PLANNING BOARD

To: Brookline Board of Appeals
From: Brookline Planning Board
Date: December 3, 2015
Subject: Construct a three-car garage, install a surface play court, and reconfigure the driveway
Location: 33 Leicester Street

Board of Appeals Hearing: December 17, 2015, at 7:05 p.m.

1 GARAGE PLAN
A2-23 / 1/4" = 1'-0"

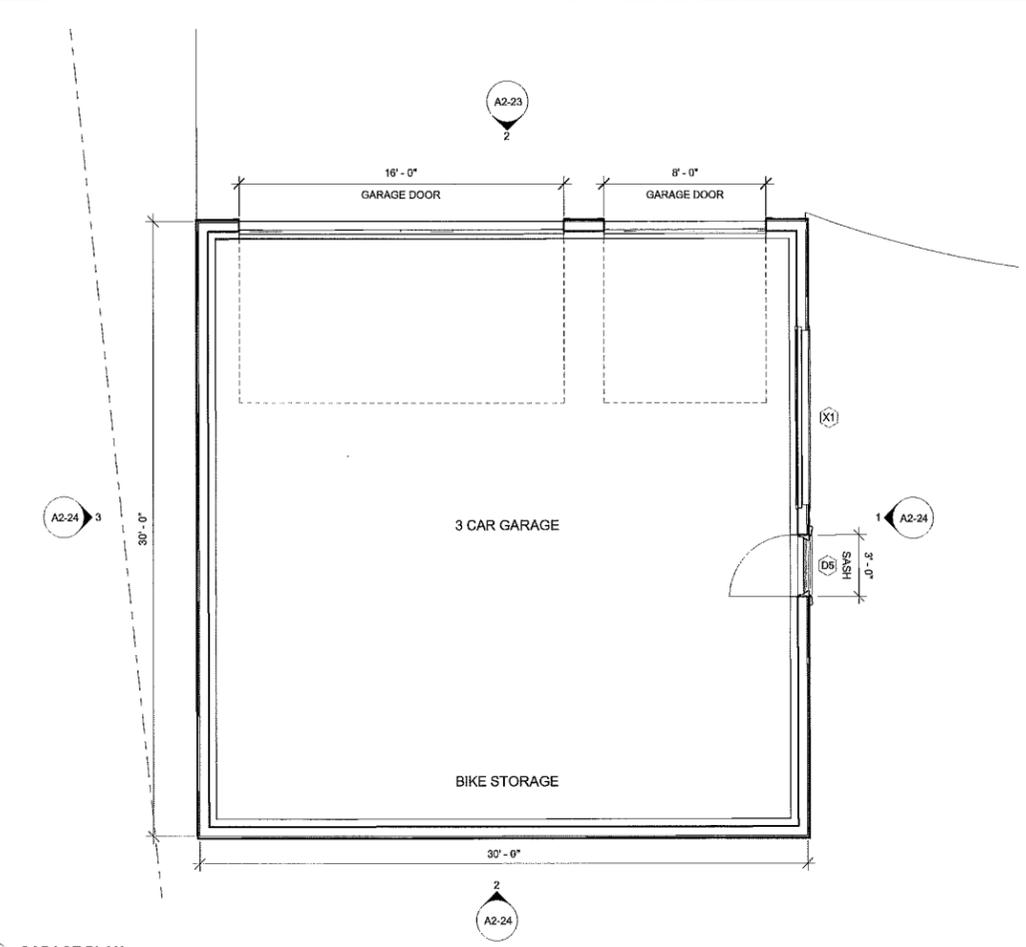
- 1. Prior to the issuance of a building permit, the applicant shall submit a final site plan, without the parking space in the circular garage, and garage floor plans, subject to the review and approval of the Assistant Director for Regulatory Planning.**

2 STREET ELEVATION - PROPOSED
A2-23 / 1/4" = 1'-0"

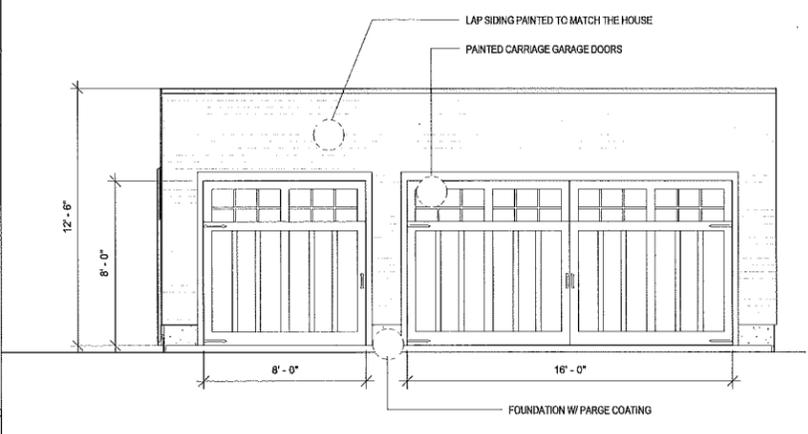
However, the Planning Board finds that garage design elements should be modified to better complement the primary structure. The Planning Board recommends the inclusion of a pitched roof and a consistent design style for proposed garage doors and windows. The Planning Board recommends that the applicant return with revised roof and façade plans for Planning Board review and approval prior to the issuance of the building permit. Also, the Planning Board did not support the surface parking space in the driveway, which is within the required front-yard setback. This feature has since been removed from the project proposal.

- 2. Prior to the issuance of a building permit, the applicant shall submit final garage elevations that incorporate design elements that are more complementary of the style of the primary structure, subject to the review and approval of the Planning Board.**
